Product Change Notification: PCN-22-135098

PCN Date: 12-APR-22

General Product Description:
M12 cable assembly with shielded version

Comparison for finish product

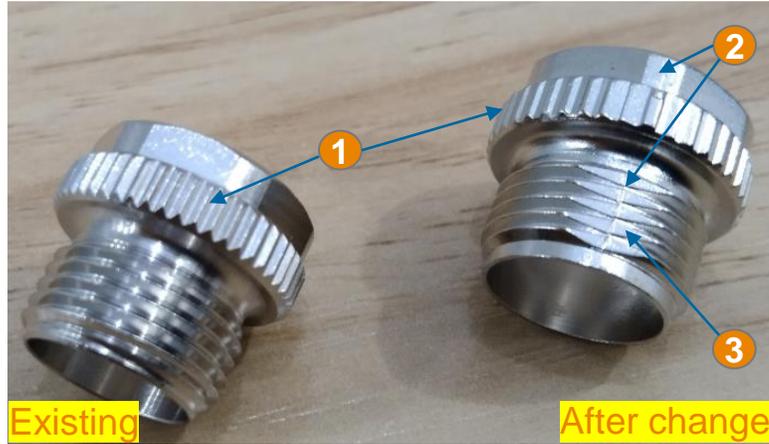
Description of Changes
1. Change the material from brass with zinc alloy. 2. Change manufacturing process from machining to die casting. 3. Slightly appearance difference on thread and nut knurling.
Other attachments:
[PCN-22-135098 details](#)

Male nut

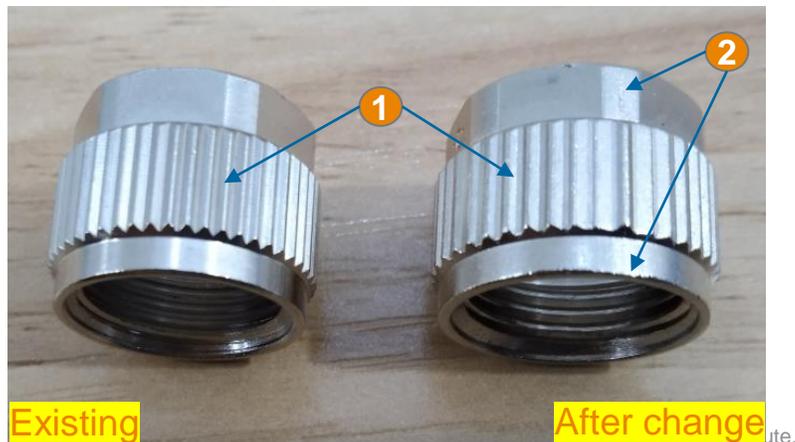
Difference

Existing

Base Material: Brass

Process: Machining

Surface treatment: plating nickel

① Knurling: thin

After change

Base Material: Zinc

Process: Die casting

Surface treatment: plating nickel

① Knurling: thick

② Parting line

③ Cut side of thread
